Access Compliance Report

Public Rights-of-Way

(Curb Ramps)

Intersection ID: 6370	Main Street: LAKE_RD	Cross Street: MILHAVEN_LN	Location: NW
ADA ID: 0D659E78A8B3	Ramp Type: Para	Initial Pass/Fail: Fail	Overall Compliance: No
Severity Score: 12.5			
Codes/Mitigation Info/Possible Solution		Field Measurements/Component Compliance

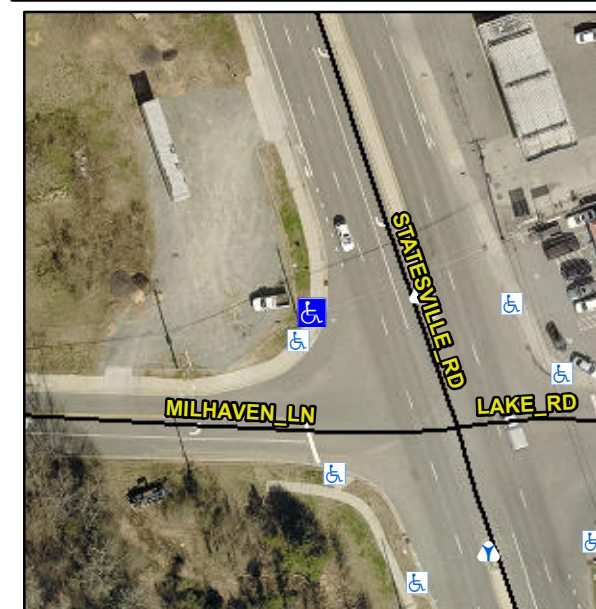
R304.3.2

Compliance	Description	Data	Compliance	Description	Data
N/A	Ramp Length LT (in)	55.0	N/A	Ramp Length RT (in)	63.0
Yes	Ramp Width LT (in)	83.5	Yes	Ramp Width RT (in)	83.0
Yes	Ramp Slope LT (%)	5.4	No	Ramp Slope RT (%)	8.8
Yes	Ramp XSlope LT (%)	1.5	Yes	Ramp XSlope RT (%)	1.7
N/A	Landing Length (in)	N/A	N/A	DWS Provided?	N/A
N/A	Landing Width (in)	N/A	N/A	DWS Contrast?	N/A
N/A	Landing Slope (%)	N/A	N/A	DWS Length (in)	N/A
N/A	Landing X Slope (%)	N/A	N/A	DWS Full Width?	N/A
N/A	Landing Curb? (Y/N)	N/A	N/A	DWS Offset (in)	N/A
N/A	Shared Landing?	N/A			
N/A	Gutter Ponding?	N/A	N/A	Gutter Slope (%)	N/A
N/A	Gutter Lip Ht (in)	N/A	N/A	Gutter X Slope (%)	N/A
N/A	Painted X Walk1?	No	N/A	Painted X Walk2?	N/A
	X Walk 1 Direction	To E		X Walk 2 Direction	N/A
N/A	X Walk 1 Width (in)	N/A	N/A	X Walk 2 Width (in)	N/A
	X Walk 1 Slope (%)	1.6		X Walk 2 Slope (%)	N/A
	X Walk 1 X Slope (%)	0.9		X Walk 2 X Slope (%)	N/A
N/A	Ramp inside XWalk1?	N/A	N/A	Ramp inside XWalk2?	N/A

Remove & Replace Entire Ramp.

\$ 1600.00
